ADDENDUM #2 7/20/18									
Proj No: MFA 9381	Drawn By:	Chkd By:	DSN By:

OREGON CONVENTION CENTER
CHILLER PLANT REDESIGN
777 NE Martin Luther King Jr Blvd, Portland, OR 97232
ELECTRICAL UPPER ENLARGED PLAN

1 ENLARGED UPPER PLAN
E2.22 SCALE: 1/4" = 1'-0"

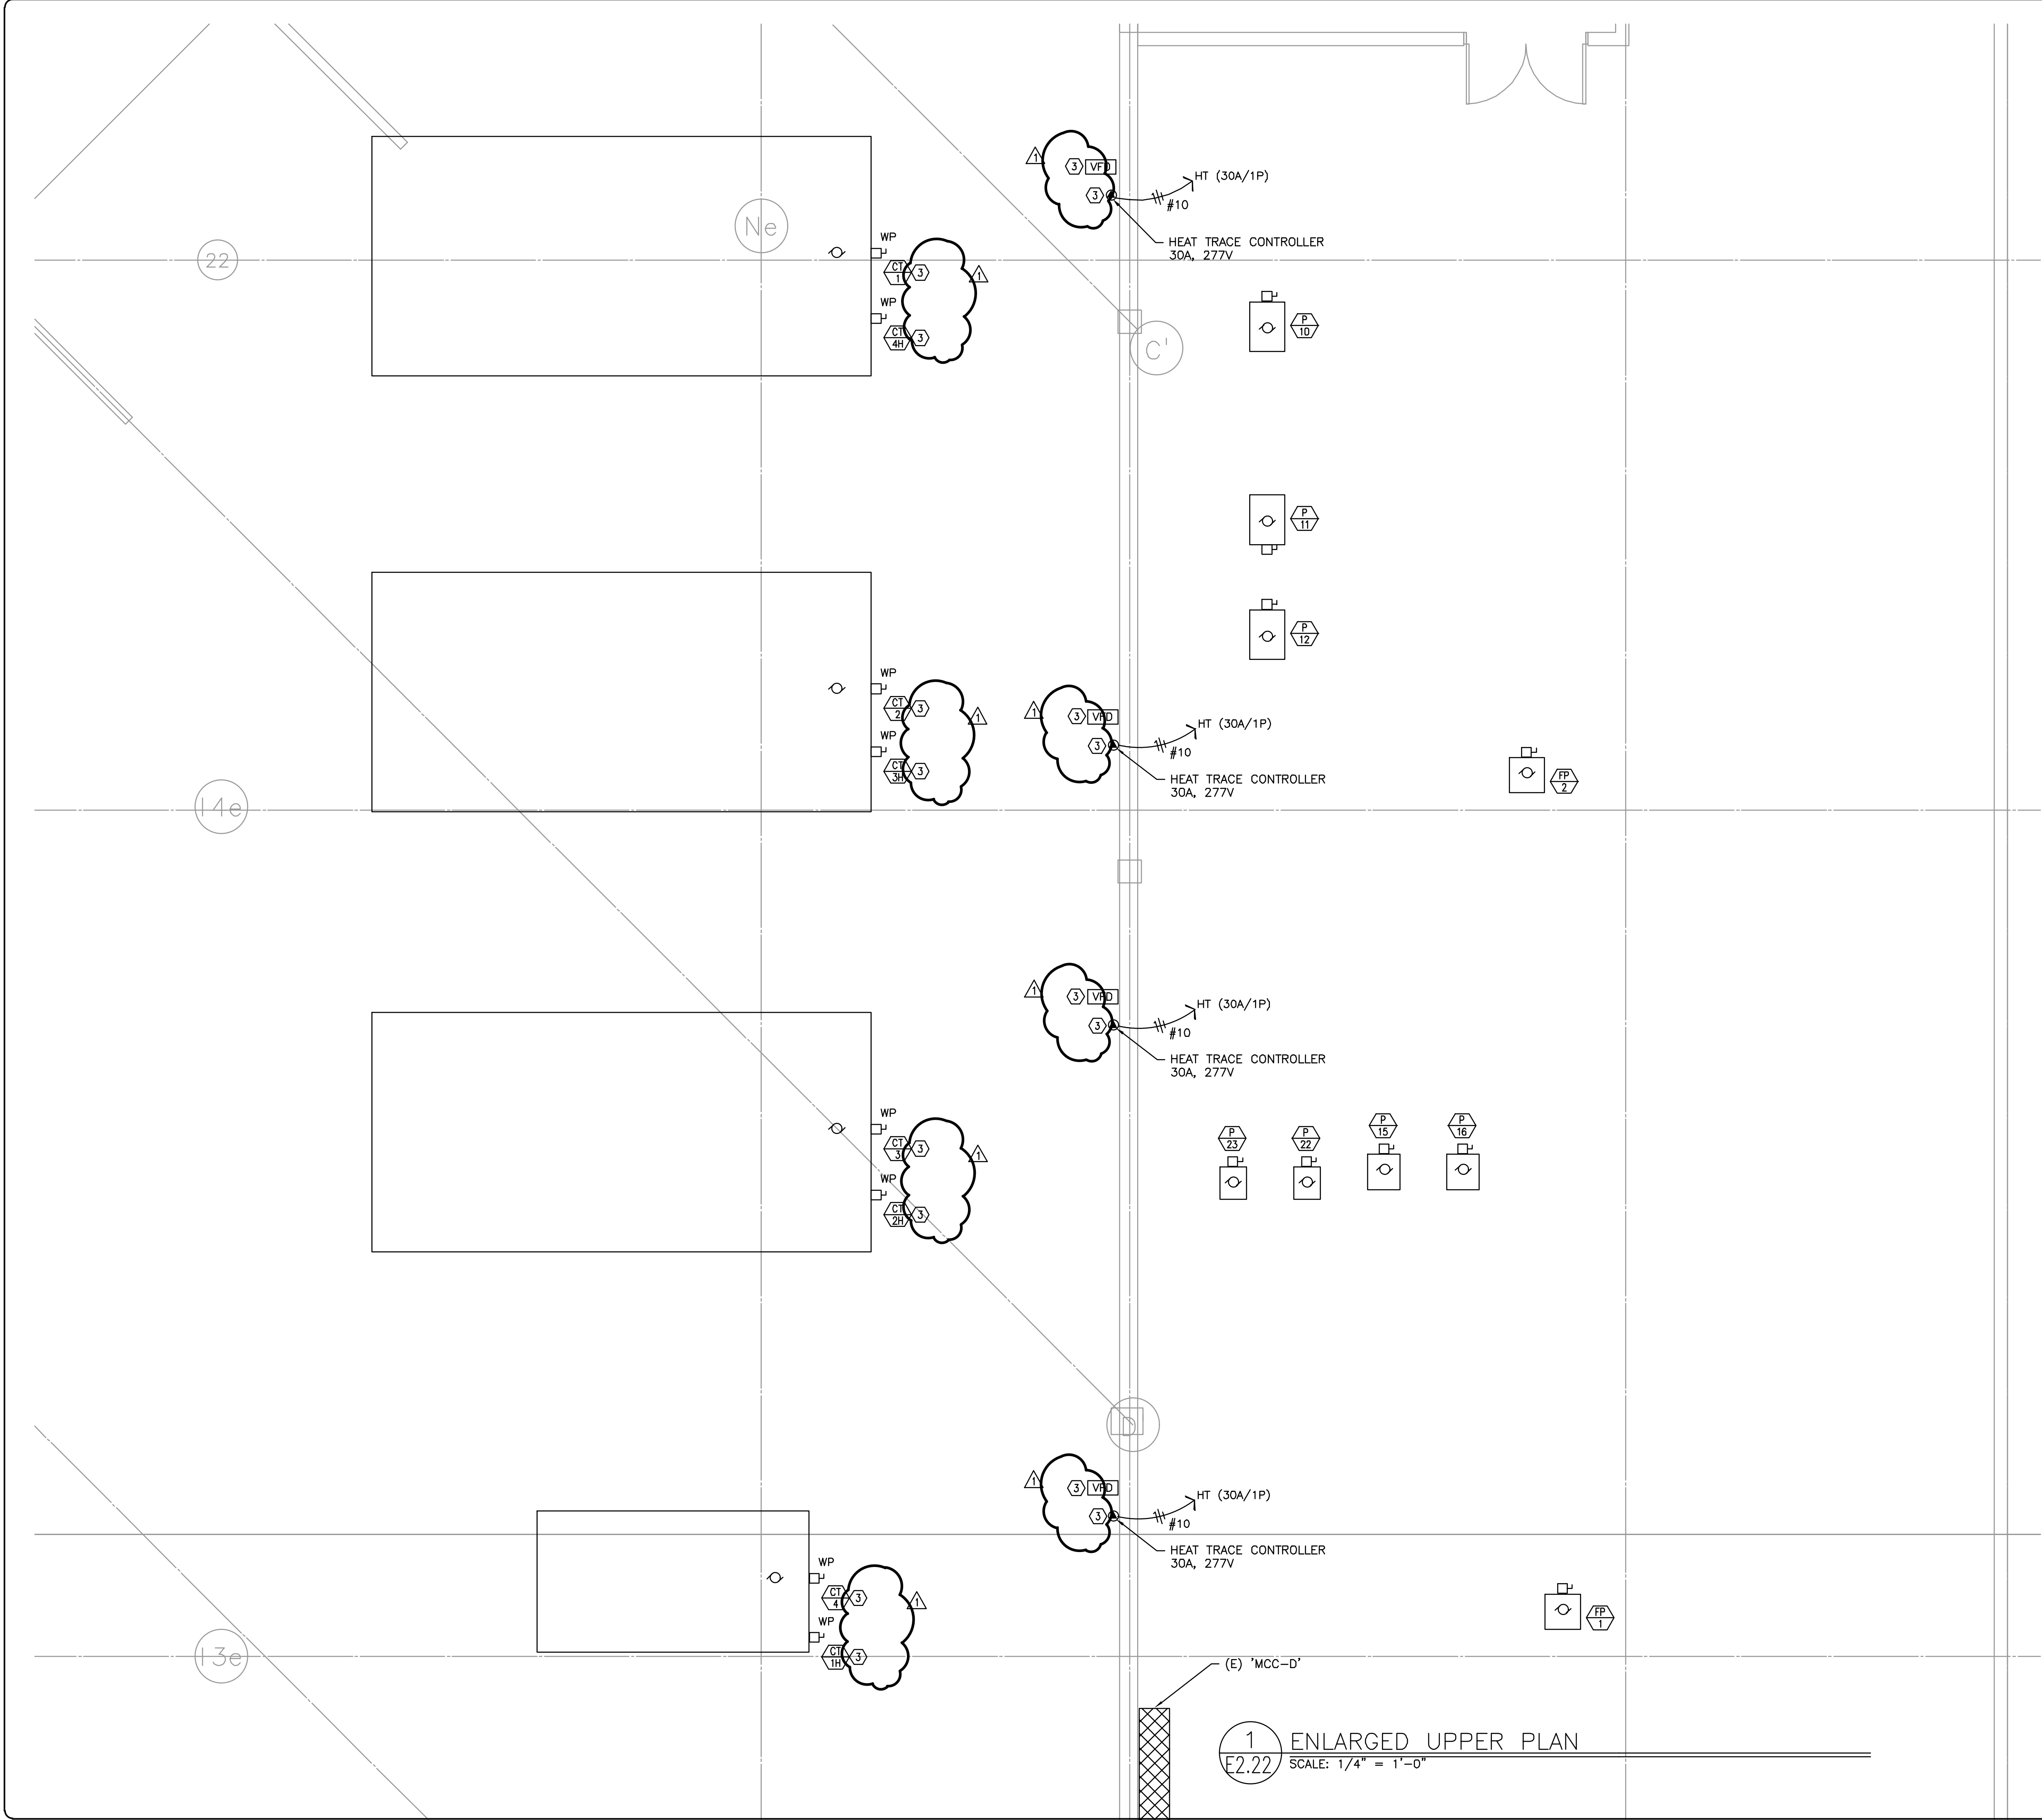
- KEYED NOTES:**
- ① CONNECT REPLACED PUMP MOTOR. CONNECT TO EXISTING MCC (MODIFIED) VIA EXTERNAL VFD AND CONNECT.
 - ② REPLACE EXISTING 100A 208Y/120V-3PH-4W 30-CIRCUIT PANELBOARD WITH 42-CIRCUIT PANELBOARD AND RECONNECT. PROVIDE WITH BREAKERS TO RE-FEED EXISTING CIRCUITS PLUS NEW CIRCUITS PER MECHANICAL EQUIPMENT SCHEDULE.
 - ③ ROUTE FEEDS TO COOLING TOWERS UNDER ROOF AND PROVIDE PROPER ROOF JACKS (COORDINATE WITH OWNER).
